7.6 All Other Instrumentation Systems Required for Safety

The information in this section of the reference ABWR DCD, including all subsections, tables, and figures, is incorporated by reference with the following departures and supplements.

Figure 7.6-4a ~~Table 7.6-4a~~ Basic Configuration of a Typical Neutron Monitoring System Division

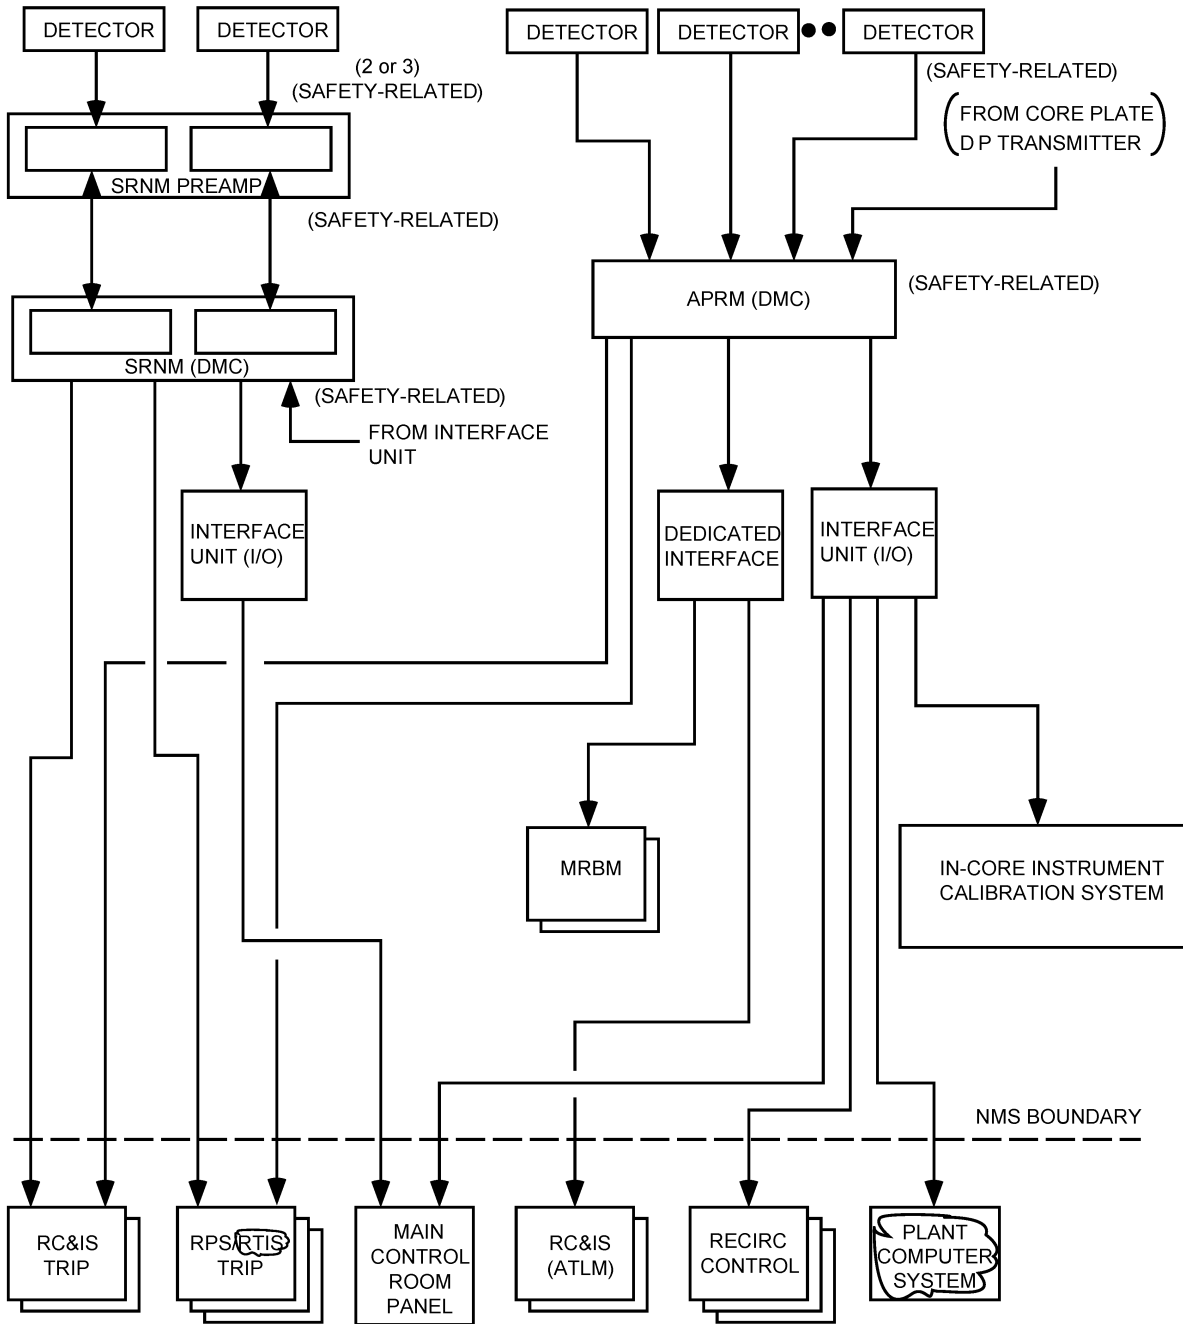
STD DEP T1 3.4-1 (Table 7.6-5 and Figures 7.6-1, 7.6-2, 7.6-4a)

STD DEP Admin (Figure 7.6-4a)

Figure 7.6-9 Instrumentation Location Definition for the Suppression Pool Temperature Monitoring System

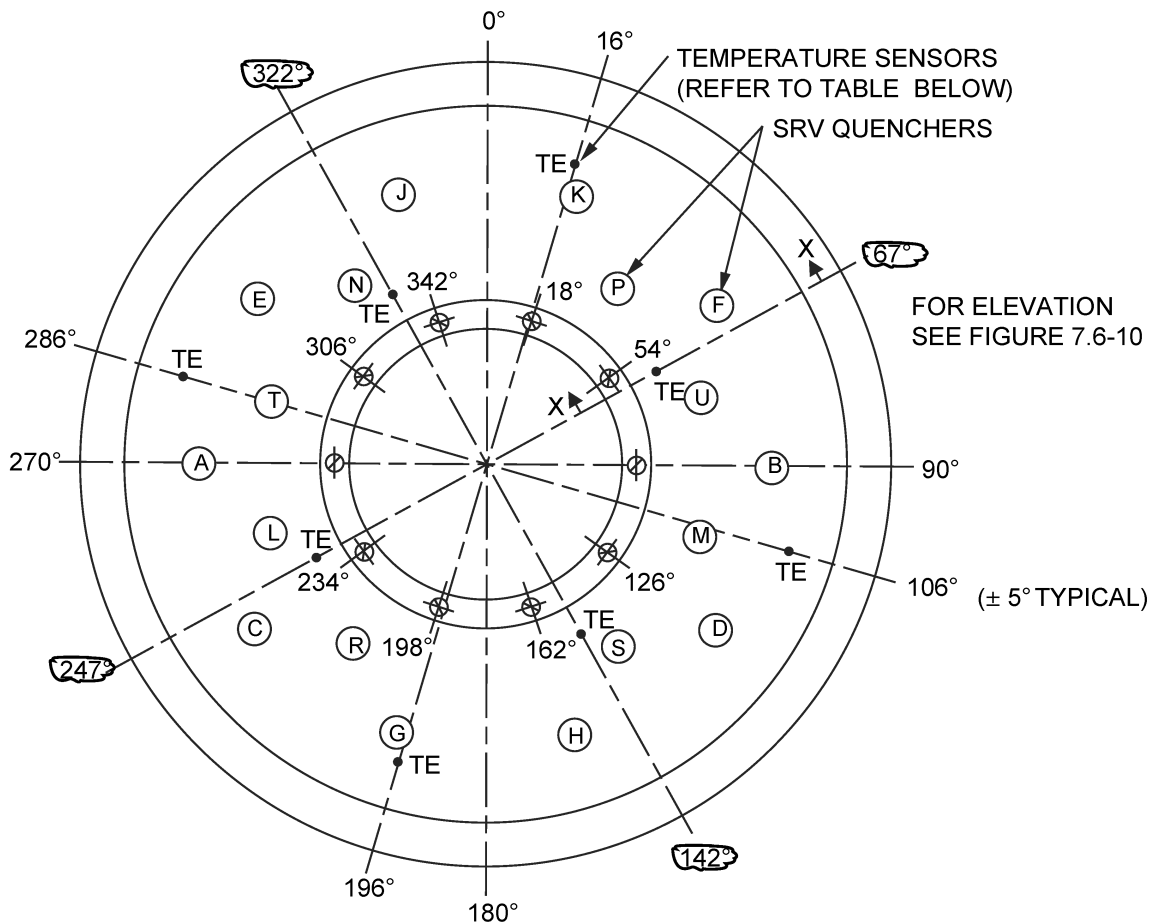
STD DEP 7.6-3 (Figures 7.6-9, 7.6-11, ~~7.6-12~~)

The SPTM System configuration is shown in Figures 7.6-9 and 7.6-10. There are eight temperature circumferential sensor locations (Figure 7.6-9), which are chosen based upon the following considerations:

Figure 7.6-14 OPRM Logic

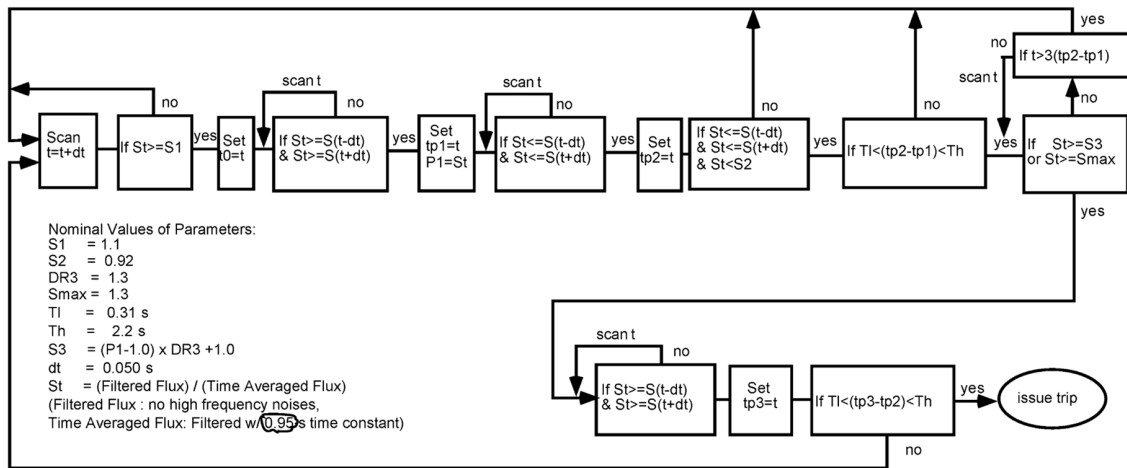
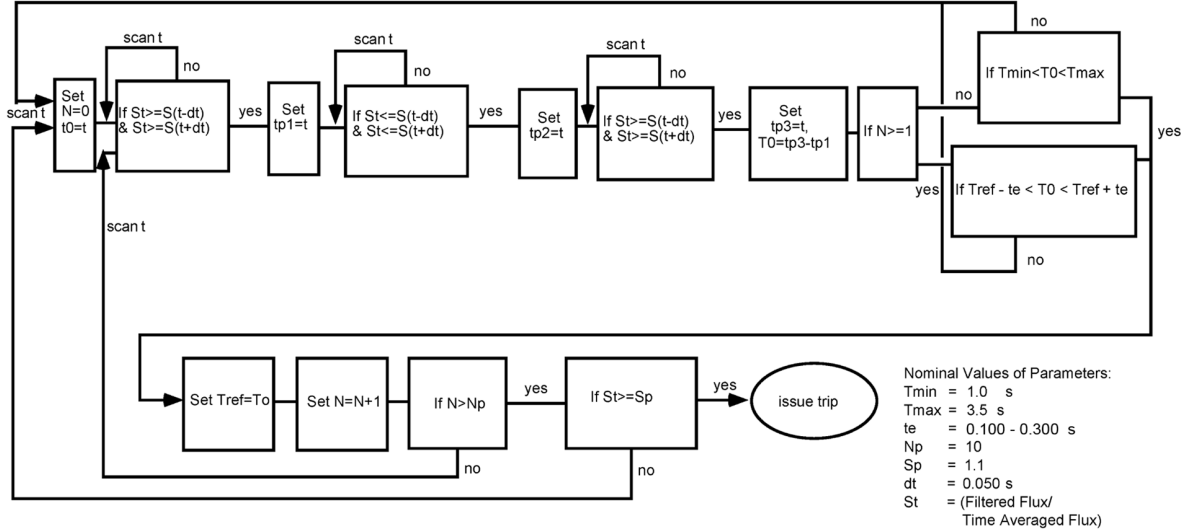
STD DEP 7.6-1 (Table 7.6-2 and Figures 7.6-2, 7.6-14)

For the OPRM trip function, the response signal of any one OPRM cell that satisfies the conditions and criteria of the trip algorithm will cause a trip of the associated OPRM channel. Figure 7.6-14 illustrates the trip algorithm logic. ~~The OPRM trip function does not have its own inoperative trip for insufficient number of total LPRM inputs in the channel. It follows the APRM's inoperative trip of insufficient number of LPRMs.~~ The OPRM function has its own inoperative trip when the channel has less than the required minimum operable cells, or there is an OPRM self-test diagnostic fault, or the APRM instrument firmware/software watchdog timer has timed out, or if there is a loss of power to the APRM instrument.

$T_{\min}=1$ s, $T_{\max}=3.5$ s, $\pm t_{\text{error}}=0.15$ s ~~0.4s~~ $=[0.100 - 0.300]$, $N_P=10$.
 (For details see Figure 7.6-14).
